# Service Bulletin

Bulletin No. 2009-72R1  
CMD 2009-12R1

## Leaks from Low-Pressure Steering Hoses on Diesel Axis Models

All Cummins MerCruiser Diesel QSD 2.8L and QSD 4.2L engines equipped with the Axis steering system built before October 15, 2009.

43088

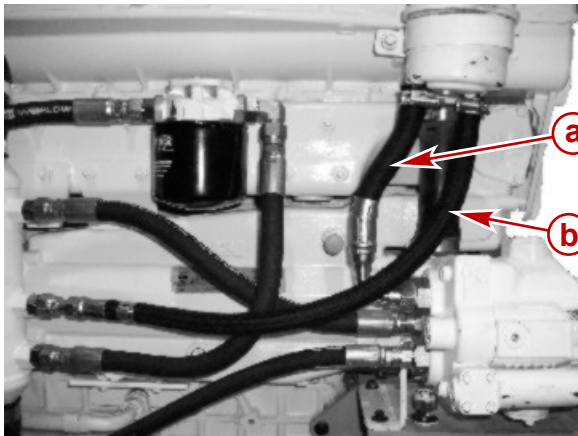
Cummins MerCruiser Diesel (CMD) has received reports of Axis-equipped QSD 2.8L and QSD 4.2L engines with hydraulic fluid leaks from the engine-mounted low-pressure hydraulic hoses. These leaks involve the hose connecting the hydraulic fluid reservoir to the hydraulic pump, and the hose between the hydraulic fluid cooler outlet and the reservoir.

- a - Reservoir-to-hydraulic pump hose and fittings
- b - Hydraulic fluid cooler outlet-to-reservoir hose and fittings

New production CMD engines equipped with the Axis system include revised hoses, clamps, and fittings that eliminate the leak issues of the old design.

Axis engines in the field should be upgraded to the new production design components.

43091

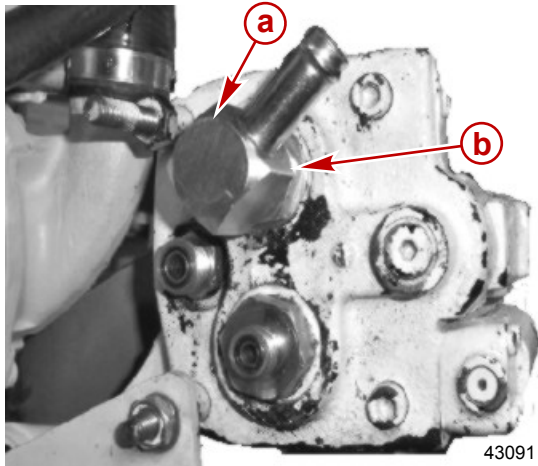
**IMPORTANT:** Overtightening the pump fitting jam nut will damage the O-ring seal and cause a fluid leak.

- Thread the new pump fitting into the pump until the O-ring seal and washer contacts the pump housing. Position the pump fitting hose barb as shown, so it does not interfere with the other pump connections. Tighten the pump fitting jam nut to specification.

a - Pump fitting  
b - Jam nut

Description	Nm	lb-in.	lb-ft
Pump fitting jam nut	30	-	22
